Template Rev 2: February 2020
CellaVision FSCA Ref: CA25-013
CellaVision FSN Ref: FSN-CV-2025-004-ROW

Field Safety Notice
Automated Digital Cell Morphology Analyzer DI-60

Field Safety Notice (FSN)
Automated Digital Cell Morphology Analyzer DI-60
Barcode reader issue

Figure 2. Image of the Honeywell Vuquest barcode reader installed in system.

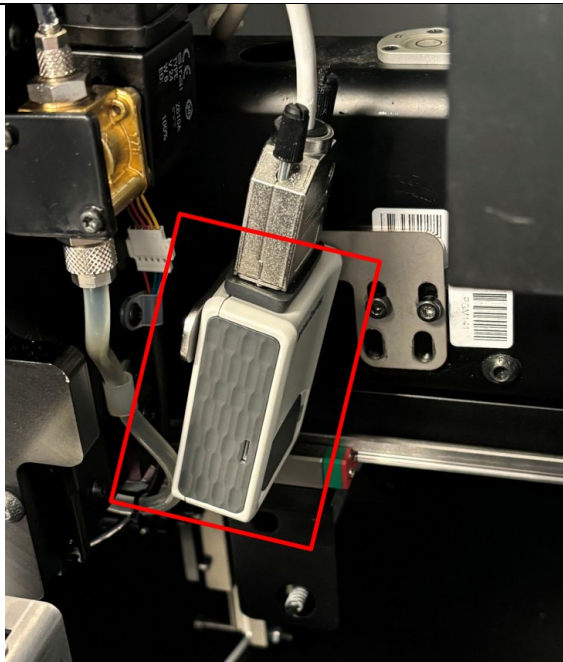
Affected units listed below in Table 1, please refer to Figure 1 and 2 for information on how to identify your unit.

2. Reason for Field Safety Corrective Action (FSCA)	
2.	1. Description of the product problem It was discovered that in some instances when a slide has an unreadable barcode there is a risk that the barcode reader accidentally reads the barcode of the previously processed slide, thus resulting in a misattribution of diagnostic results. The precondition for the issue to occur is that a slide with an unreadable barcode is run after a slide with a readable barcode in a DI-60 with either a Honeywell Vuquest or Jada FM-5 barcode reader. In this case there is a risk that the barcode reader instead reads the barcode of the slide located in the shuttle return position and thus attributes the results from the slide in fetch position to the ID of the slide in return position. If the healthcare professional performing the review is not attentive this has the potential to lead to a wrong diagnosis. It is less likely that the problem occurs when Sysmex standard barcodes, where the barcode is smaller and located to the left, are used.

Action (FSCA) is being initiated to mitigate the risk and ensure continued patient safety. Internal investigation has confirmed that the malfunction is caused by conditions in the CCU firmware in combination with newer barcode readers (Honeywell Vuquest and Jada FM-5). Specifically, the barcode reader has a field of view that is too large, allowing capture of the barcode on the return slide (located next to the fetch slide). The barcode reader continues to attempt barcode reading after the gripper has released the return slide, thereby exposing its barcode. To eliminate the root causes, corrective actions have been implemented in the CCU firmware (version 4.2.7), which includes: - Reducing the effective field of view of the barcode reader. - Preventing additional barcode reading attempts once the gripper has released the return slide. Firmware version 4.2.7 has already been introduced in manufacturing. As part of this FSCA, all affected DI-60 instruments in the field will be updated with the corrected firmware via Distributor's service engineers. Distributors are required to confirm completion of the update. These actions are justified to prevent recurrence of the malfunction, to mitigate the risk of slide misidentification, and to ensure patient safety.

3.	4. Action Being Taken by the Manufacturer	
	☒ On-site device modification/inspection ☒ Software upgrade A new Firmware (version 4.2.7) has been developed to solve the problem associated with the barcode reader. This new version shall be installed in affected units through a Field Safety Corrective Action. The installation will be performed by Sysmex service personnel, who will contact affected users to schedule a time for firmware update. Refer to Technical Note TN-148 for information and details regarding the Field Safety Corrective Action.	
3.	5. By when should the action be completed?	As soon as possible
3.	6. Is the FSN required to be communicated to the patient /lay user?	No
